**ADDENDUM  
NO. 2**

**Portage Township School - Portage High School Exterior Envelope Restoration  
Portage IN, 46368**

RE: PORTAGE TOWNSHIP SCHOOLS  
HIGH SCHOOL - EXTERIOR ENVELOPE RESTORATION  
6450 US Highway 6  
Portage, Indiana

DATE: January 12, 2022

1  
C1.2

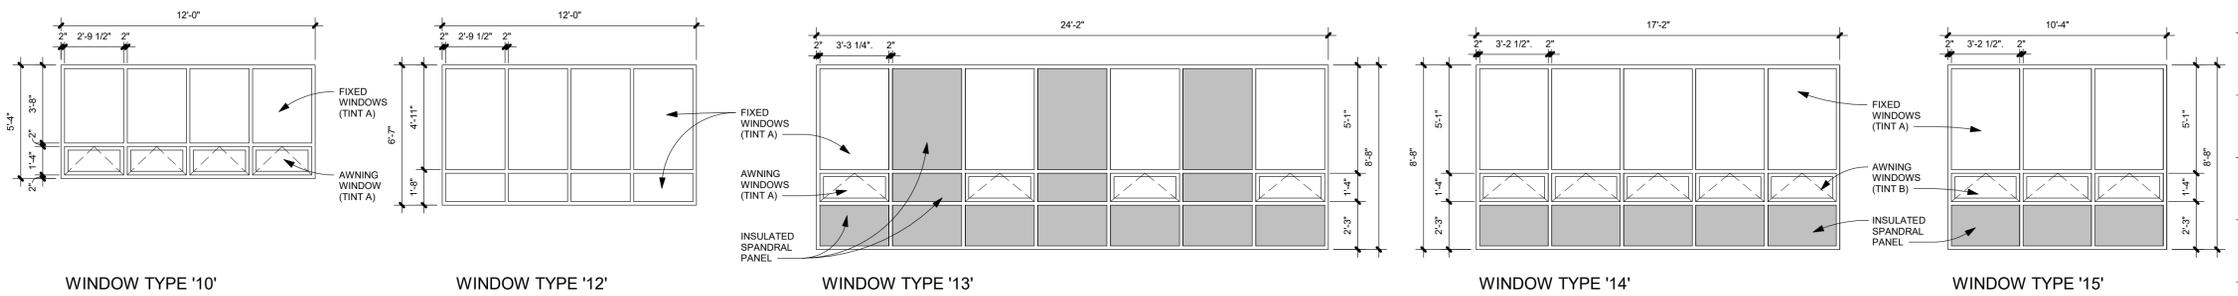
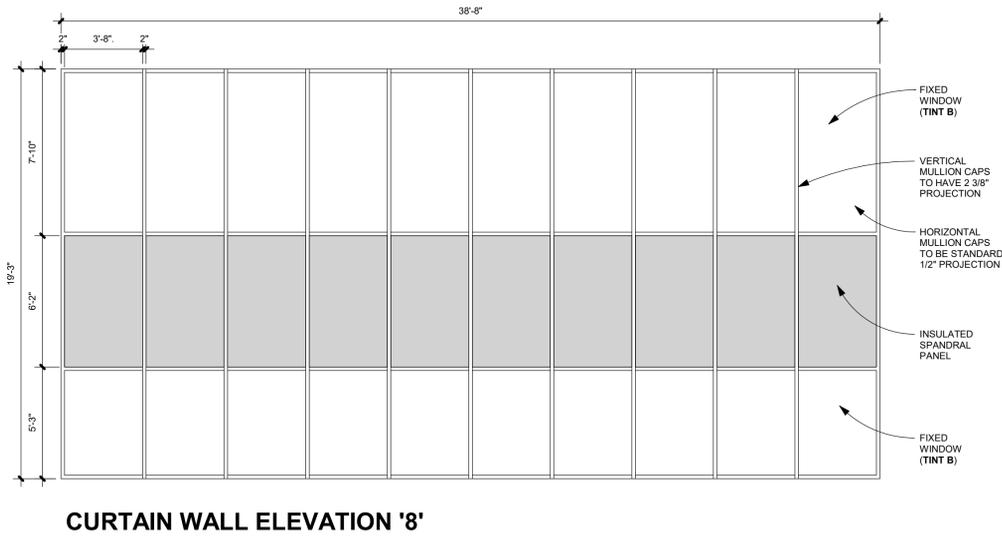
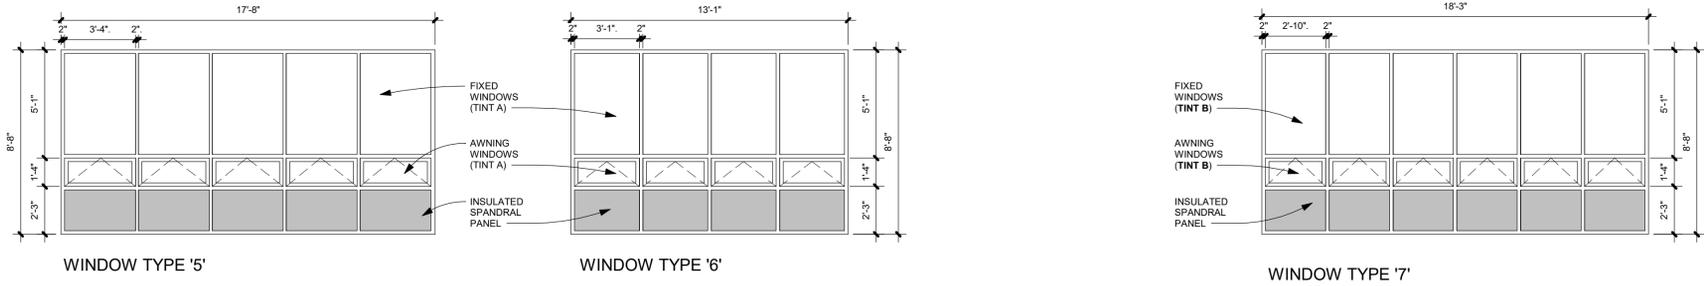
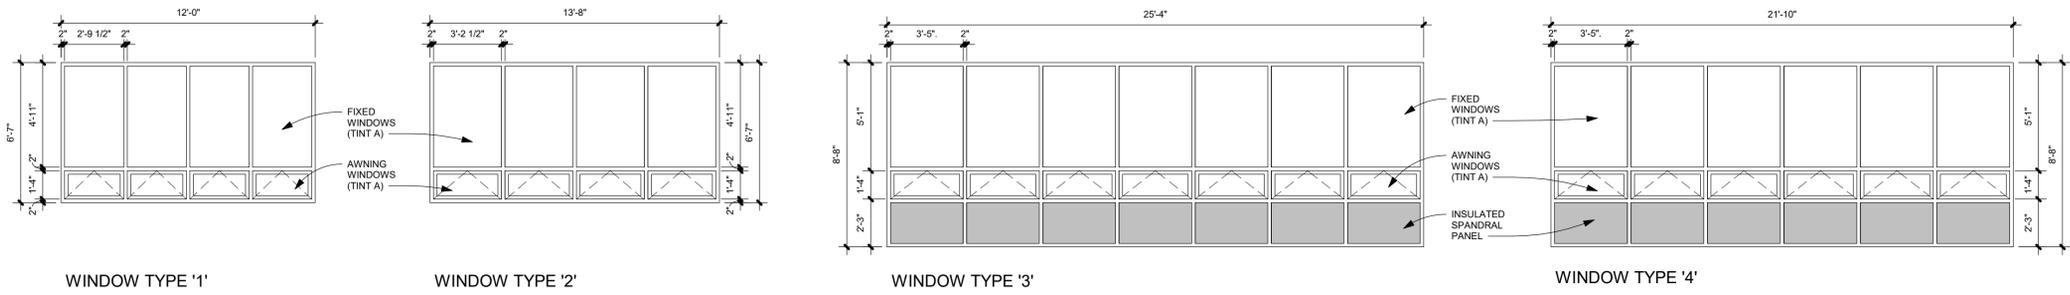
- b) Visible Light Reflectance: 8% exterior, 11% interior.
    - c) Solar Heat Gain Coefficient: Maximum 0.30.
6. **DRAWINGS**; Sheet No. C1.2:
- a. Add PIPE RAIL ELEVATION 1/C1.2 to this sheet.

- b. SITE PLAN:
    - 1) Add callout for PIPE RAIL ELEVATION 1/C1.2 at Loading Dock.
    - 2) Revise quantity of concrete slab replacement at Loading Dock Ramp from 450 s.f. to 150 s.f.

8. **DRAWINGS**; Sheet No. A2.7; EXTERIOR ELEVATIONS; NORTH ELEVATION 4/A2.7; add note which reads, "REPLACE EXISTING PIPE RAIL SYSTEM AT LOADING DOCK RAMP. SEE DETAIL 1/C1.2."
